JERSEY CENTRAL POWER & LIGHT COMPANY

FEDERAL AND STATE COMMENTS

AEC DRAFT ENVIRONMENTAL IMPACT STATEMENT

OYSTER CREEK NUCLEAR GENERATING STATION

FIGURE 2.2-11

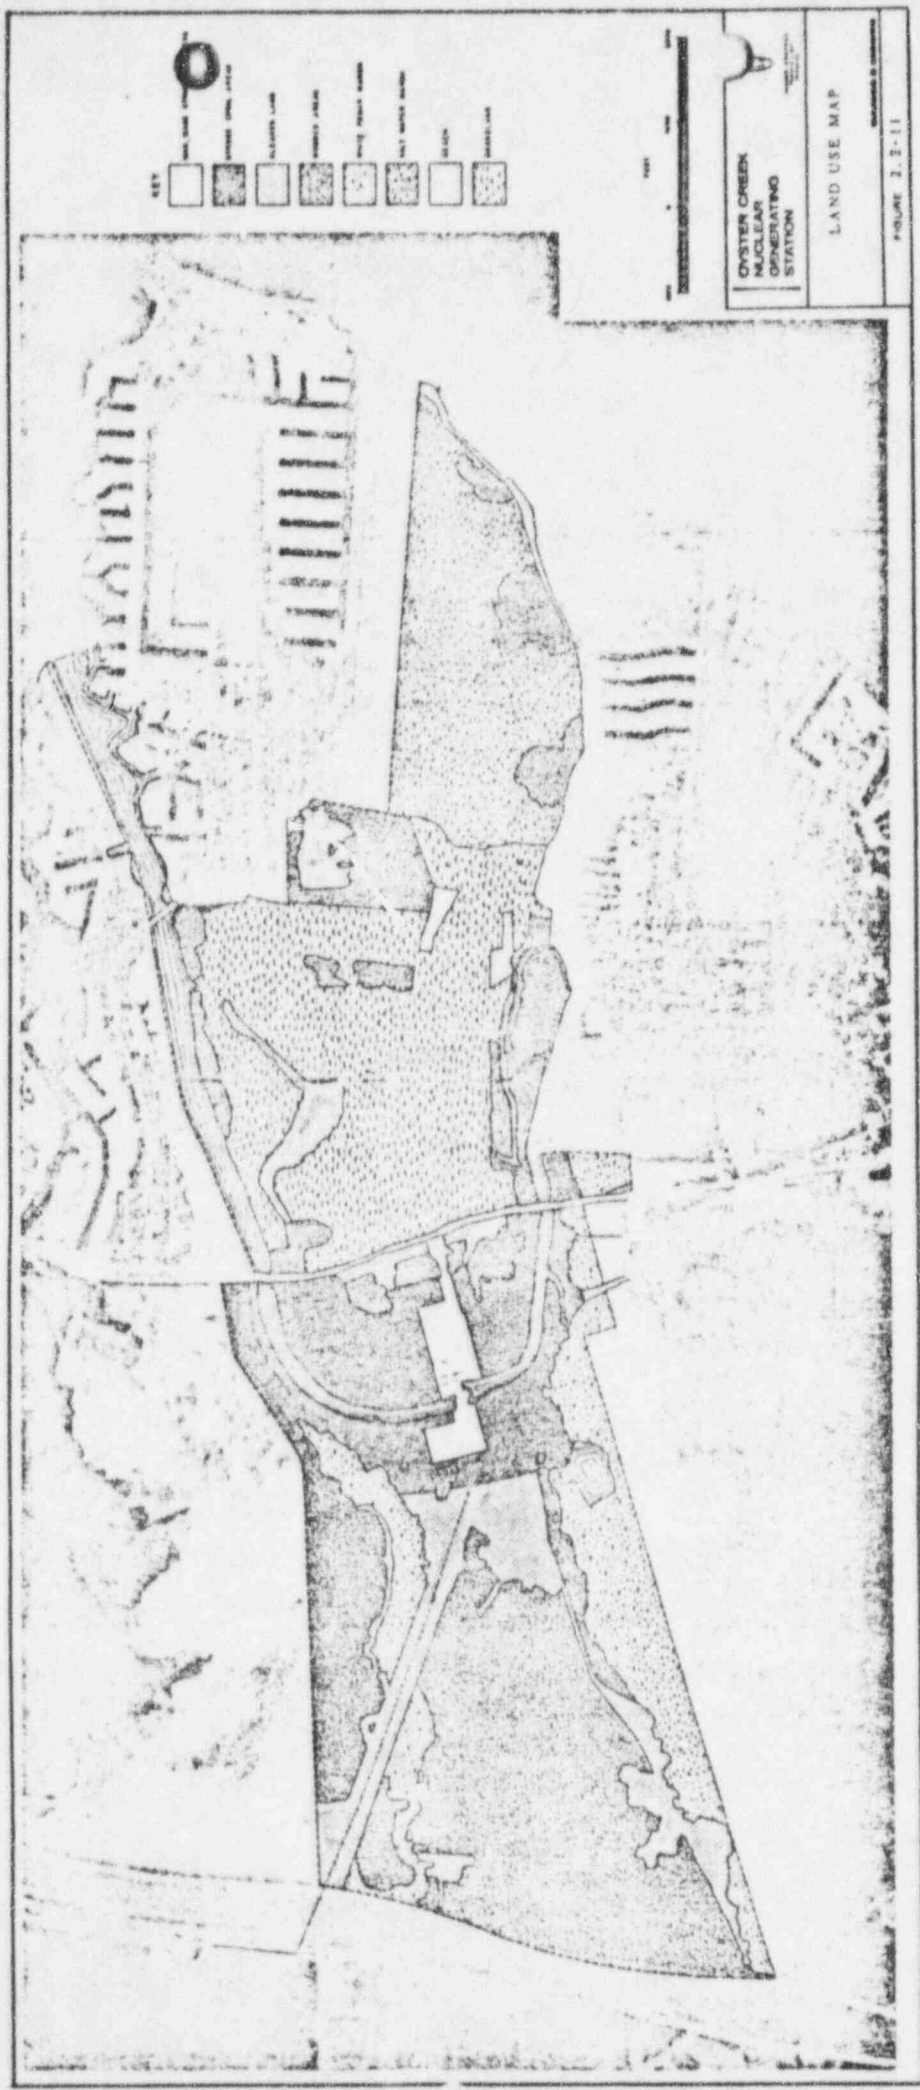
The removal of 352 acres of wildlife habitat during construction was not significant because similar mobile organisms' habitat was available nearby. A description of land use patterns within the plant site may be helpful.

Land use patterns within the plant site fall into either of two broad classifications: some land has been altered or developed by man for his use, and the remainder of the site has been left in its natural state. Figure 2.2-11 reproduced from the Oyster Creek Nuclear Generating Station Environmental Report depicts the location of the land devoted to each of these uses. Land developed by man includes that occupied by the generating station and grounds, the switch yard, transmission right-of-way, several spoil areas, cleared land, transportation right-of-way, and areas designated for industrial or recreational land use, residences, and farm structures. Natural areas are identified as forested or wooded land, salt water marsh, white cedar swamps, and land previously used for pasture and cultivation.

There were 352 acres of land within the plant site utilized during construction of the plant and transmission right-of-way: 288 acres of spoil and cleared area; 33.5 acres of right-of-way for railroads and transmission lines; 22 acres occupied by the generating plant and switch yard; and 8.5 acres set aside for an emergency fire pond on Oyster Creek. The spoil within the plant site was deposited during dredging the South Branch of Forked River and Oyster Creek. The cleared areas include the transmission right-of-way, areas adjacent to U. S. Highway 9, and the Garden State Parkway. Approximately a 33 acre area near the Garden State Parkway was cleared of vegetation by the former owner before the Applicant acquired the land. Vegetation is slowly being reestablished in all of these areas. Regrowth ranges from very sparse areas to areas with thick ground cover and some trees, such as white cedar. Soil in these areas is sandy and relatively infertile, therefore, regrowth of vegetation has been slow.

Disturbances to the land during construction of plant facilities included the removal of some pine and hardwood forest, the dredging of a canal, and the replacement of some white cedar swamp and salt water marsh with spoil from dredging and site excavation. The effect of these activities resulted in the elimination of some small non-mobile mammals (i.e., moles), reptiles, and amphibians that lived on the disturbed area surrounding the plant. The short-term effect of the removal of 352 acres of wildlife habitat during construction did not significantly affect mobile organism movements, because similar habitat was available nearby.
